# UNITED STATES PATENT AND TRADEMARK OFFICE

APPLICATION NO.	FILING DATE	FIRST NAMED INVENTOR	ATTORNEY DOCKET NO.	CONFIRMATION NO.
10/810,456	03/26/2004	Cristopher Frost	H0006486-1170	9338

<b>Office Action Summary</b>	<b>Application No.</b> 10/810,456	<b>Applicant(s)</b> FROST ET AL.	
	<b>Examiner</b> Aaron M. Dunwoody	<b>Art Unit</b> 3679

**DETAILED ACTION**

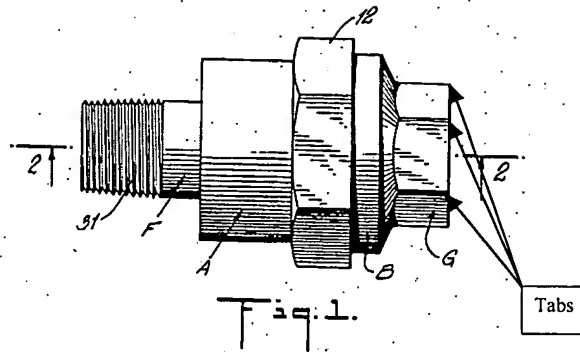
In regards to claim 1, Jacobson discloses a joint for connecting a duct to a port comprising:

an annular flange (23), having a sealing flange disposed radially outward therefrom, the annular flange fixedly attached to the duct;

a female mating flange (A) , having female threads disposed internally thereon, the female mating flange fixedly attached to the port; and

an annular seat collar (B) having male threads disposed externally thereon; wherein the male threads are threadably attachable to the female threads; and

the annular seat collar having a surface contacting the sealing flange when the joint is assembled; and

a plurality of tabs (see Figure below) spaced around an outer annular surface of the annular seat collar.

In regards to claim 2, Jacobson discloses a bellows seal (C) sealingly positioned between the sealing flange and the female mating flange.

Applicant's arguments filed 10/11/2005 have been fully considered but they are not persuasive. Applicant argues Jacobson does not disclose a plurality of spaced around an outer annular surface of the annular seat collar. The Examiner disagrees. In the Figure above, Jacobson clearly illustrates a plurality of spaced around an outer annular surface of the annular seat collar. Therefore, Jacobson meets the claim limitation.
